GROUP	MODEL
ELE	2022-2023MY Carnival (KA4)
NUMBER	DATE
263 (Rev 1, 10/27/2022)	August 2022

TECHNICAL SERVICE BULLETIN

SUBJECT: **LOW PITCH & HIGH PITCH HORN REPLACEMENT**

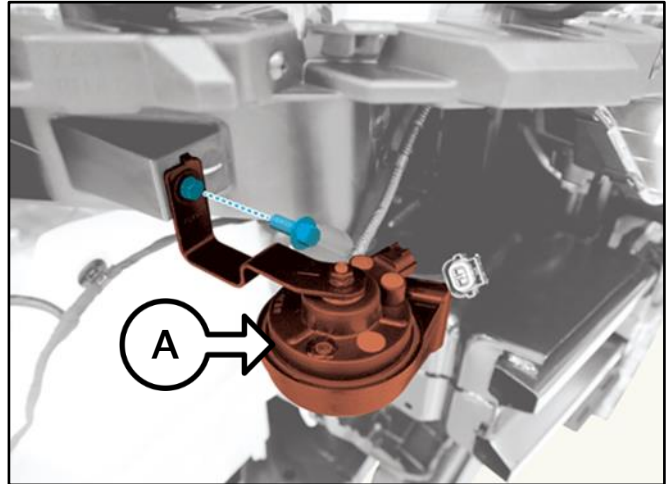
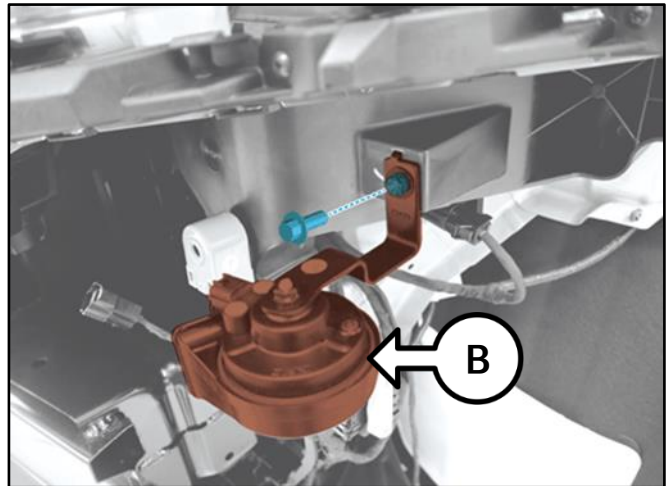
1. Replace the both the low (A) and high (B) pitch horns by referring to "Body Electrical System → Horn → Removal and Installation" in the applicable Shop Manual on KGIS.

Even if only one (1) of the horns is inoperative, replace both horns.

2. Confirm normal horn operation.
